CONSUMERS POWER COMPANY  
Docket 50-255  
Request for Change to the Technical Specifications  
License DPR-20

For the reasons hereinafter set forth, it is requested that the Technical Specifications contained in Provisional Operating License DPR-20, Docket 50-255, issued to Consumers Power Company on October 16, 1972, for the Palisades Plant be changed as described in Section I below:

ATTACHMENT 2

Figure 6.2-2

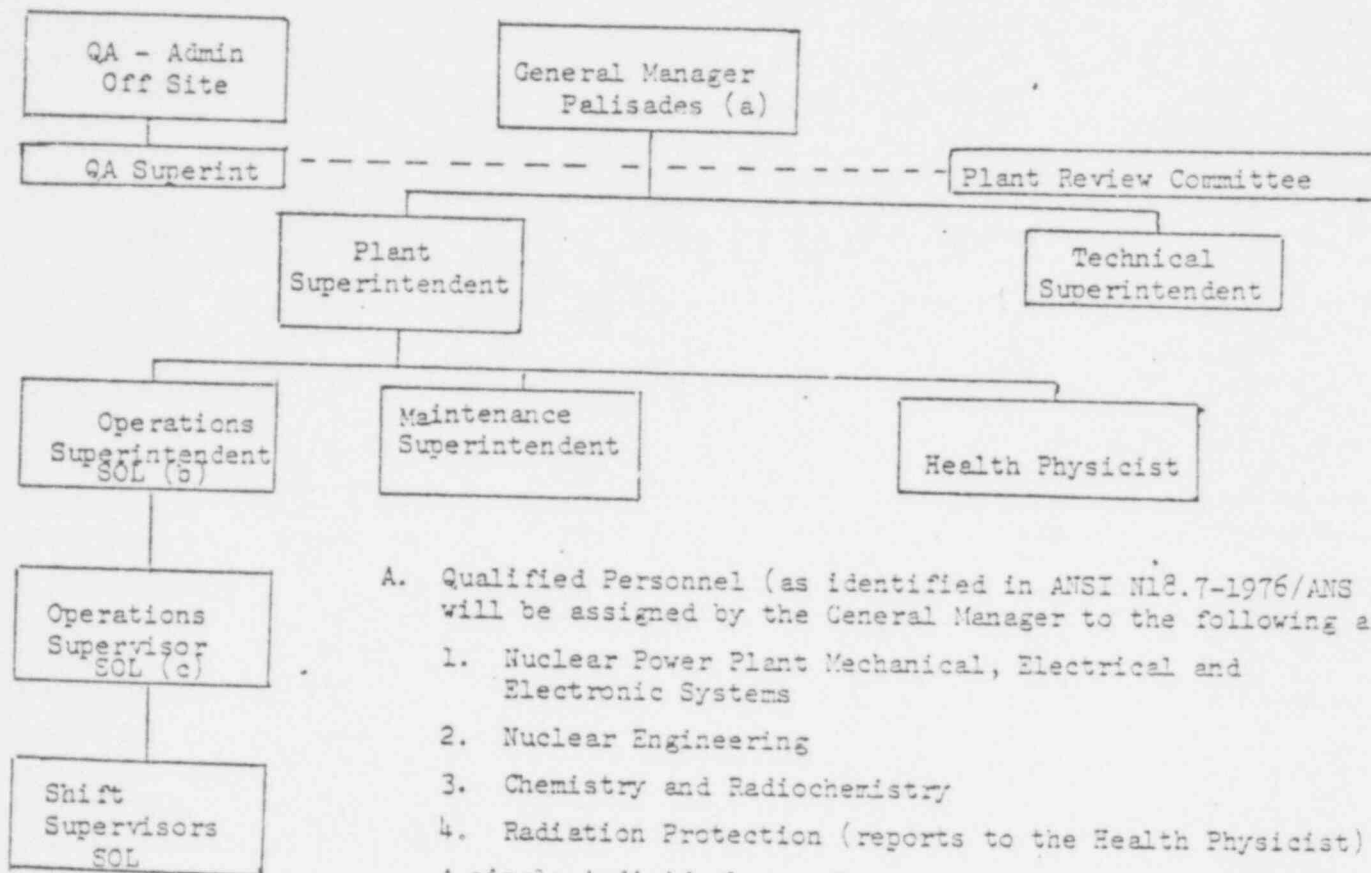
All proposed changes within the text of the Administrative Controls Section (Chapter 6) of the Technical Specifications are consistent with the changes on the organization charts (Figures 6.2-1 and 6.2-2).

The following proposed changes of the Palisades Plant Technical Specifications result from a corporate realignment of the Consumers Power Energy Supply organization. Technical Specification page changes are attached.

Figure 6.2-1  
Figure 6.2-2  
Section 6.1.1  
Section 6.4.1  
Section 6.5.1.1  
Section 6.5.1.2  
Section 6.5.1.6.a  
Section 6.5.1.6.e  
Section 6.5.1.7.a  
Section 6.5.1.7.c  
Section 6.5.2  
Section 6.5.2.2  
Section 6.5.2.3  
Section 6.5.2.8  
Section 6.5.2.9  
Section 6.5.2.10.a  
Section 6.5.2.10.b  
Section 6.5.2.10.c  
Section 6.7.1.b  
Section 6.7.1.d  
Section 6.8.2  
Section 6.8.3.c

A. Qualified Personnel (as identified in ANSI N18.7-1976/ANS 3.2) will be assigned by the General Manager to the following areas:

- (a) Responsible for the Plant Fire Protection Program.
- (b) The Operations Superintendant need not hold an SOL provided he meets the other requirements of 6.3.1 of these Technical Specifications and the position of "Operations Supervisor" is filled. Under these conditions, the Operations Supervisor shall be responsible for directing the activities of licensed operators.
- (c) This position need not be filled if the Operations Superintendant holds an SOL. However, when the Operations Supervisor position is filled, the individual shall hold an SOL.
